**From:** Craig Harlin <clharlin@sequoyahfuels.com>  
**To:** Myron Fliegel <MHF1@nrc.gov>, Bill von Till <rvv@nrc.gov>  
**Date:** 2/15/05 2:20PM  
**Subject:** GWMP Review - Docket 40-8027

## Groundwater Availability West of Pond 2

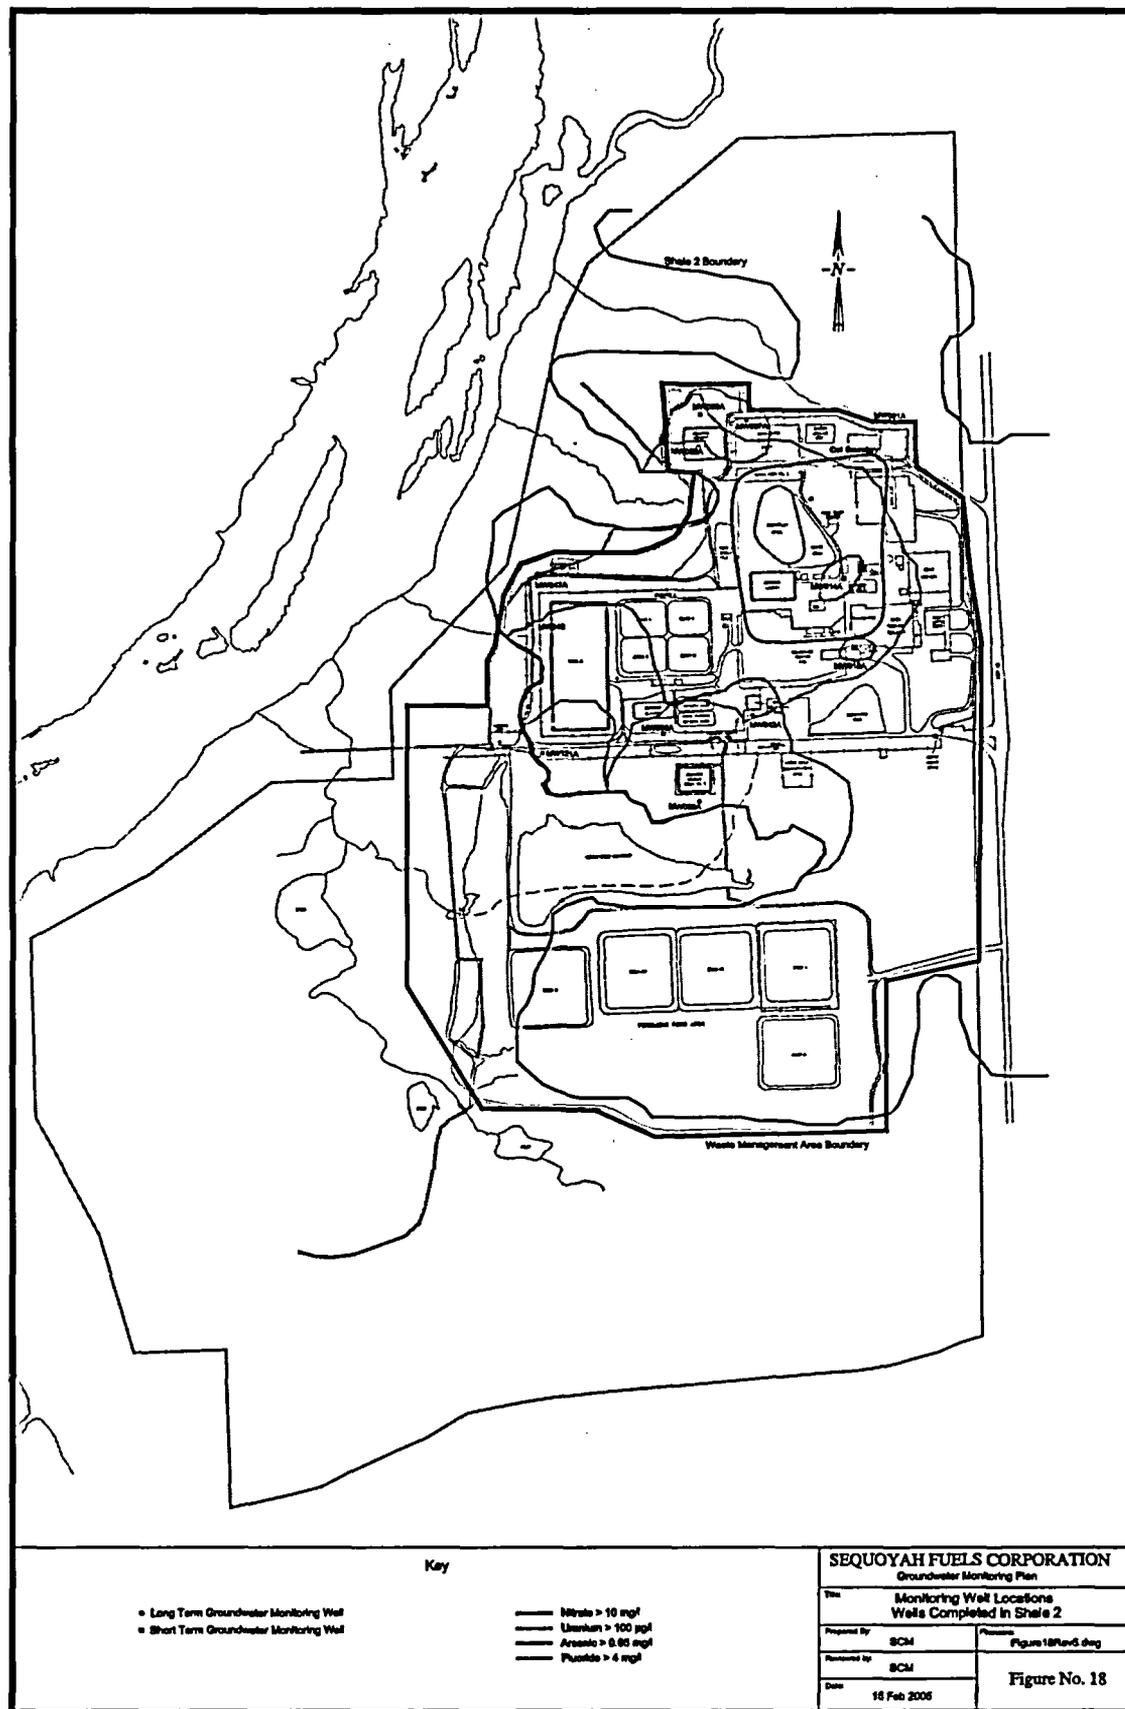
NRC proposed that SFC place a monitoring well between MW048 and MW121A west of Pond 2 to monitor the Shale 2 Unit groundwater in this area. See attached figure for well locations. There are two existing wells between MW048 and MW121A that could be used to monitor Shale 2 Unit groundwater. Both wells (MW041 and MW051) are at western edge of the Shale 2 Unit boundary.

The day prior to sampling each monitoring well is purged. SFC has not been able to purge or sample MW041 and MW051 since they were dry or insufficient water was present to sample. The table below is a summary of notes made in the field logbook for these locations:

If a note is made that a well is "Dry" or a "Trace" amount of water is present there was not enough water to purge or sample the well. On April 9, 2002, two tenths of a gallon of water was purged from MW051. However, insufficient water was present to obtain a sample from the well following purging.

An investigation trench was installed west of Pond 2 to investigate the hydrogeological conditions in this area. The location of the trench is shown on the attached figure. There was very little water encounter north of Port Road. Small amounts of water would seep into the trench just north of Port Road over a period of 12 to 24 hours. Less water was encountered toward the north end of the trench. After several days a small amount of water was observed in a puddle at the north end of the trench. As the investigation trench progressed south of Port Road water could be observed seeping into the trench as the excavation was conducted. Water encountered throughout the bottom of this trench is associated with Unit 4 Shale and soil just above Unit 4 Shale. No water was found that could be attributed to Shale 2 or 3. (See CAP, Appendix B, for investigation details.)

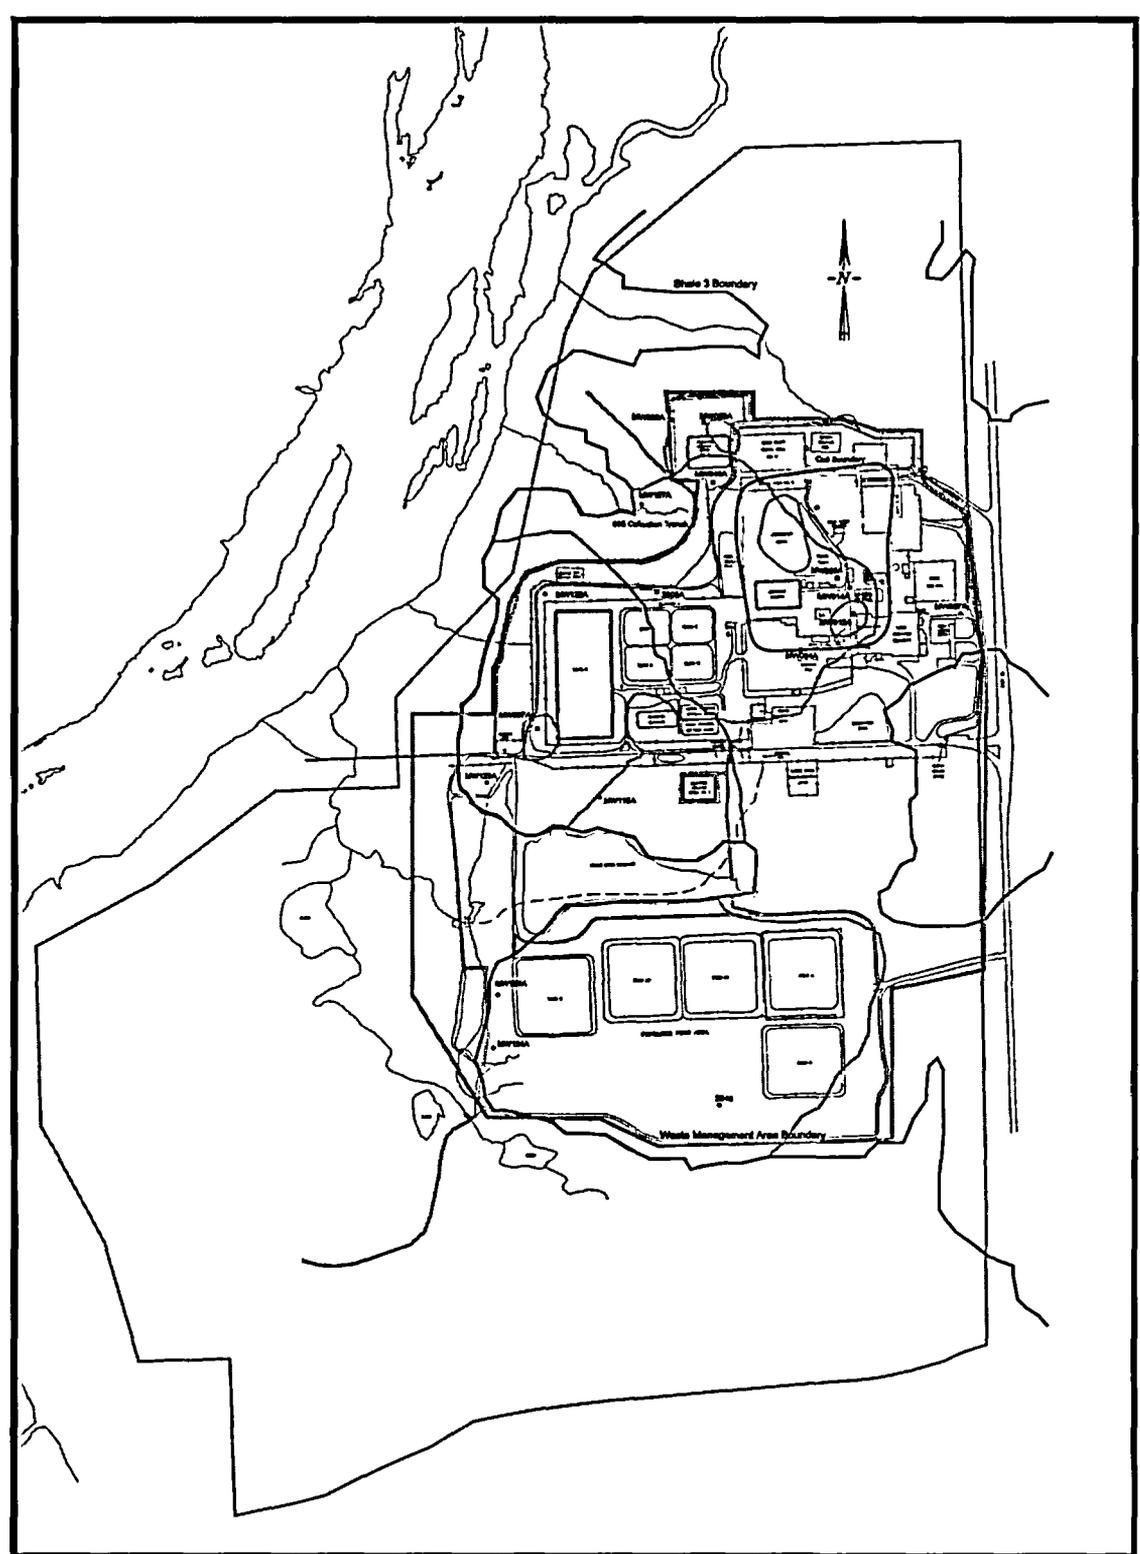
After evaluating the wells in Shale units 2 and 3 that Bill suggested we keep, we have decided to add some additional wells to our program. We will add MW065A and MW067A in Shale 2, and MW012A, MW049A, MW057A, 2303A, and a new well (MW130A) west of Pond 5. Attached are two drawings showing the approximate location of these wells.
